APPLICATION FOR MODIFICATION ASSESSMENT REPORT

Application Number:	Mod2020/0563
----------------------------	--------------

Responsible Officer:	Megan Surtees
Land to be developed (Address):	Lot 46 DP 13620, 967 Barrenjoey Road PALM BEACH NSW 2108
Proposed Development:	Modification of Development Consent N0272/16 granted for the demolition of existing dwelling house and construction of a new dwelling house and swimming pool
Zoning:	E4 Environmental Living
Development Permissible:	Yes
Existing Use Rights:	No
Consent Authority:	Northern Beaches Council
Land and Environment Court Action:	No
Owner:	SMJ Investments Pty Ltd
Applicant:	Blue Sky Building Designs Pty Ltd

Image 1. Northern elevation envelope breach.

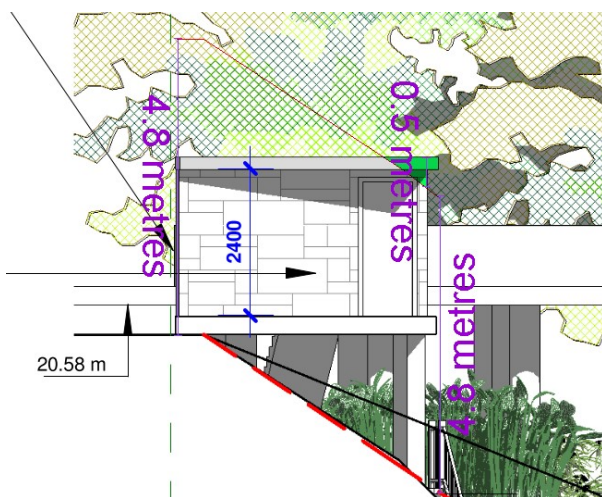
This control requires development to be set within the building envelope, which is to be projected at 45 degrees from 3.5m above the existing ground level and measured from the side boundaries. The proposed awning over the pedestrian access gate will encroach slightly within the building envelope along the northern elevation, with a maximum encroachment of 0.5m, thus presenting a variation of 14.2% (see Image 1 below).

This control stipulates that should the building footprint be located on a slope greater than 30%, a merit consideration may be applied. The building footprint of the proposed pedestrian gate is located on a slope of approximately 67.1%. As such, the variation can be applied and a merit consideration is conducted below.

The proposed plans indicated that the pedestrian access gate and awning will be constructed of a sandstone wall with awning above. This design and material finishes will blend with the previously approved dwelling and be consistent with the existing developments along Barrenjoey Road. The proposed pedestrian access gate is located on the ground level, with a maximum height of approximately 1.9m - thus being in scale with the height of the natural environment.
